Sherwood Tailings Reclamation Plan

Responses to NRC Comments

Prepared by Washington Department of Health
Environmental Health Programs
Division of Radiation Protection
Waste Management Section

July 2000

PROBABLE FLOW PATH
FROM DIVERSION CHANNEL

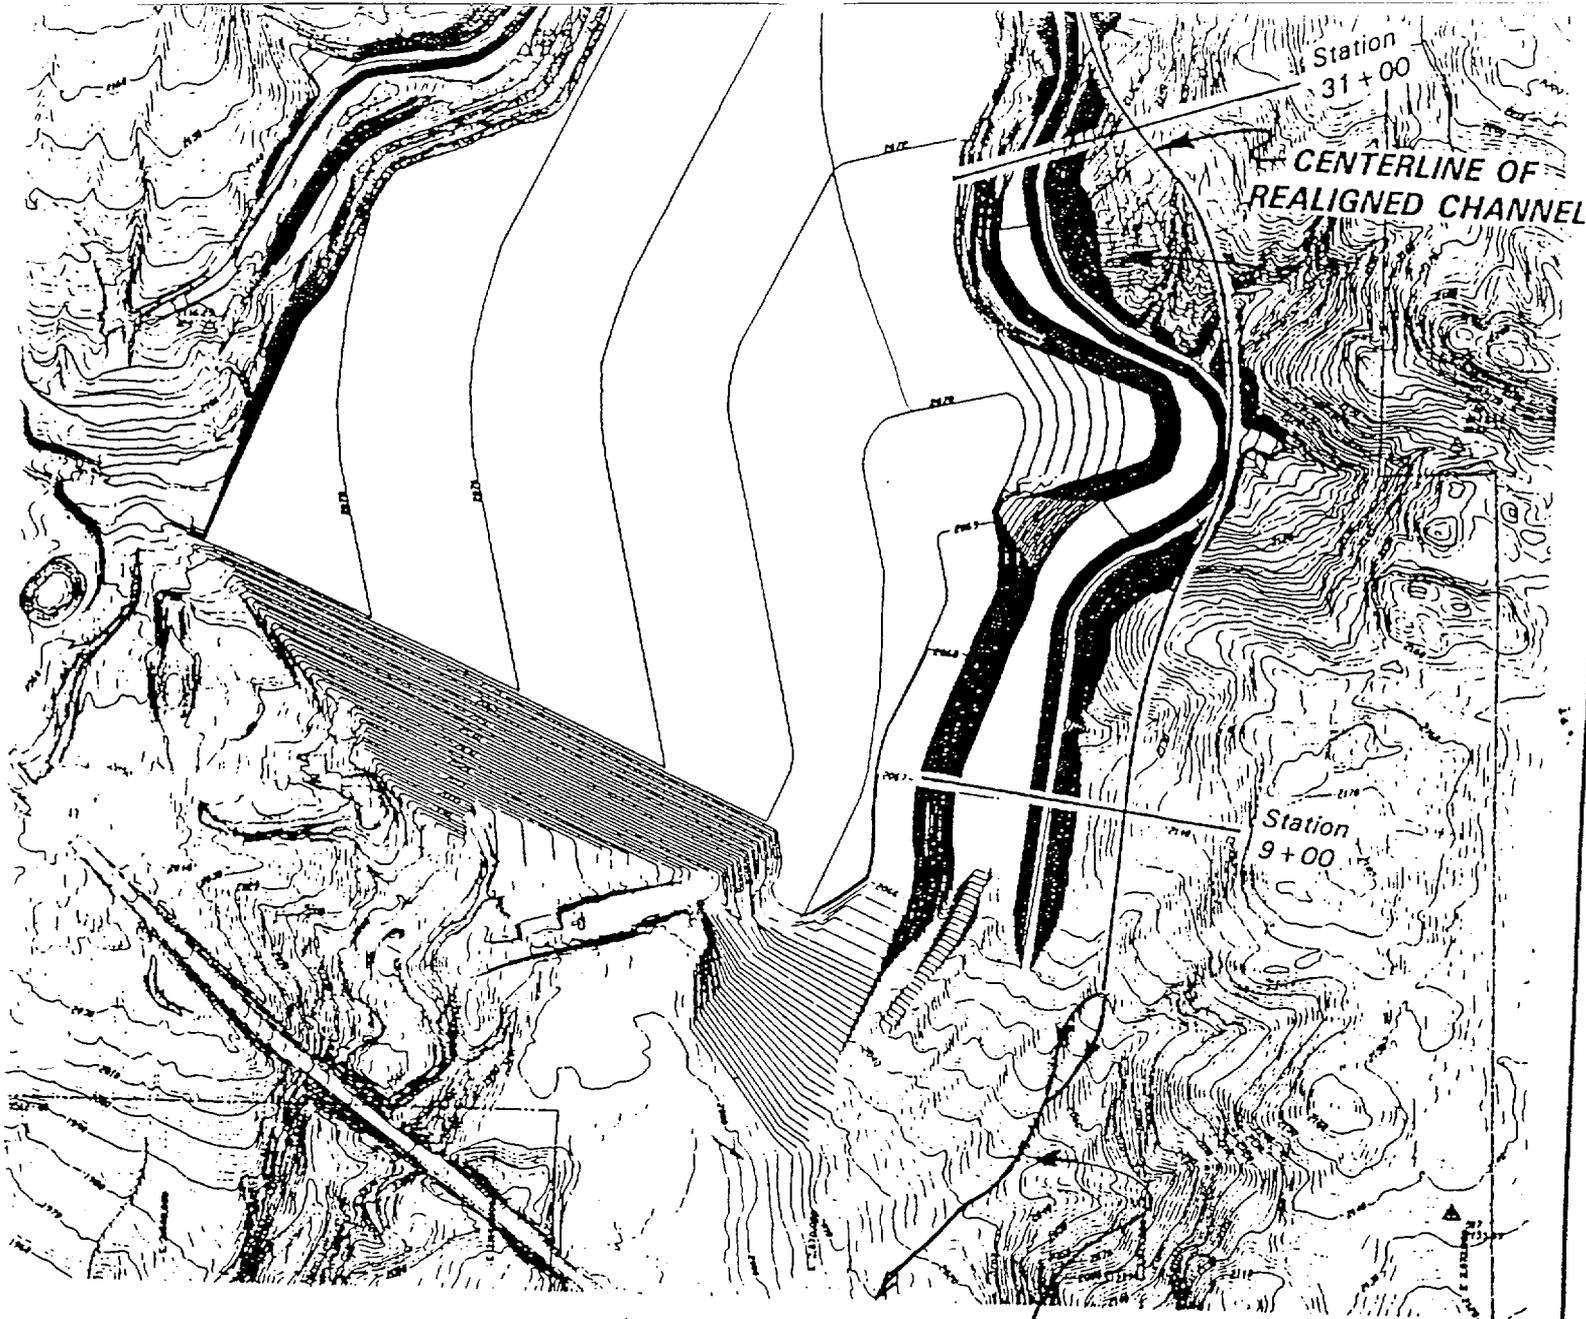
Diversion Channel Outfall Erosion Protection - If the diversion channel alignment is changed as shown in Figure 4 of the October 9, 1995 submittal then the consultant proposes to eliminate the erosion protection at the diversion channel outfall. The rationale for this is that although erosion will occur during large storm events, it is very unlikely that the erosion path will intercept the tailings impoundment.

The divergence will be defined by the angle Θ only if there are no topographic features that will confine the flow further. In looking at the topography downstream of the diversion channel outfall, there are a number of swales that would confine the flow and train it to a path even narrower than computed by the consultant. The attached figure shows the most likely flow path for diversion channel discharges based on the topography of the hillside below the channel outlet. This flow path remains a substantial distance away from the tailings cap.

FIGURE 1  
 LOCATION OF  
 NEEDED RIPRAP MODIFICATIONS

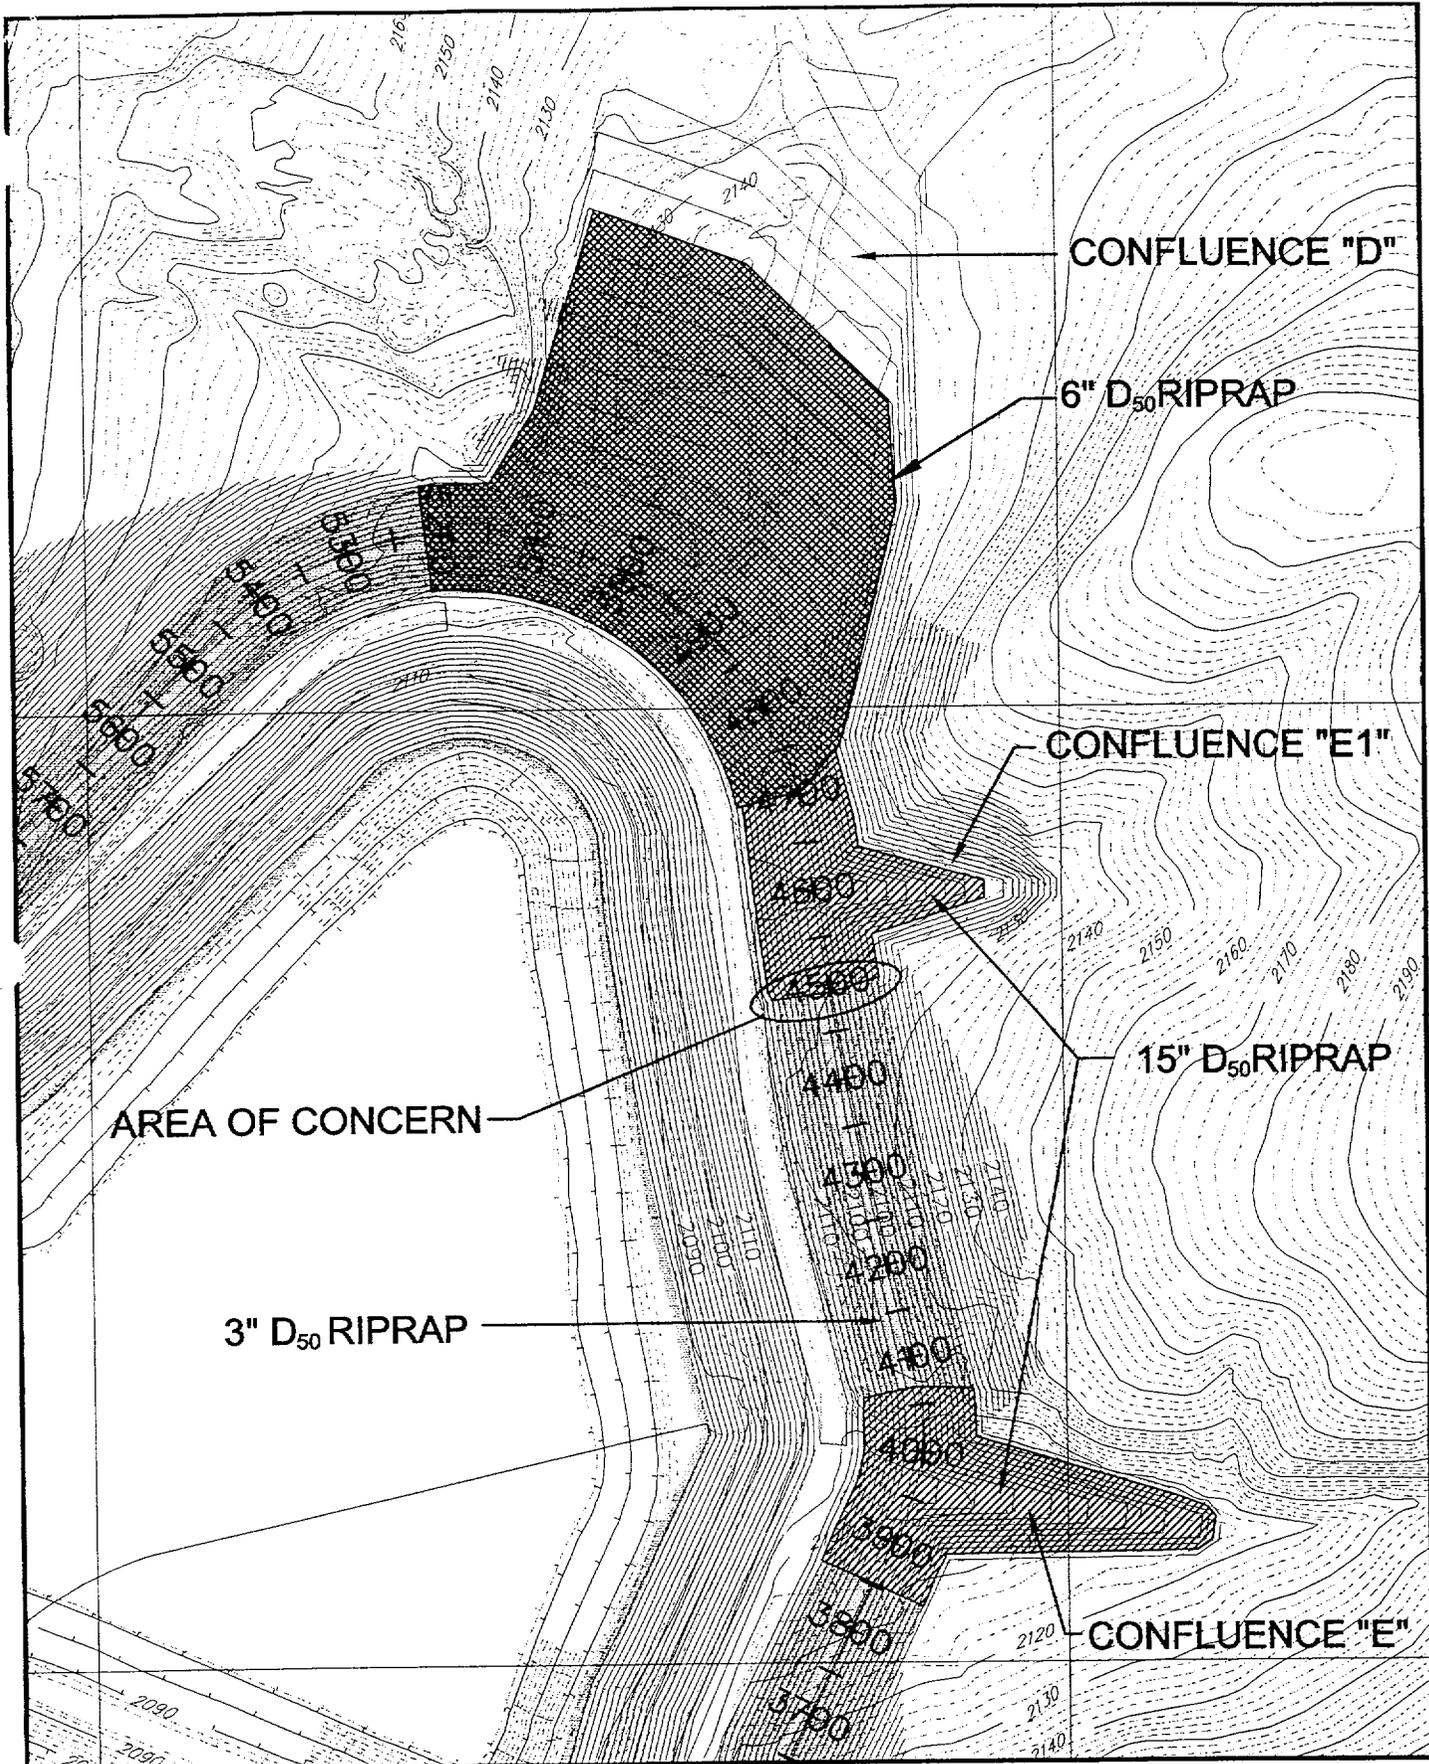
The area in question exists at the transition between confluence E1 and the diversion channel immediately south of the confluence. The general location is shown on Figure 1 (attached). At the transition from 15-inch riprap in the confluence to 3-inch riprap in the diversion channel, there is an abrupt elevation change, as the bottom elevation of the channel is approximately 3-4 inches lower than the elevation of the bottom of the confluence. This elevation difference appears to be a result of heavy construction activity which occurred over the 3-inch riprap in the diversion channel as the larger riprap was being placed in the confluence. This heavy construction activity appears to have pushed the 3-inch riprap into the underlying filter and foundation soil.
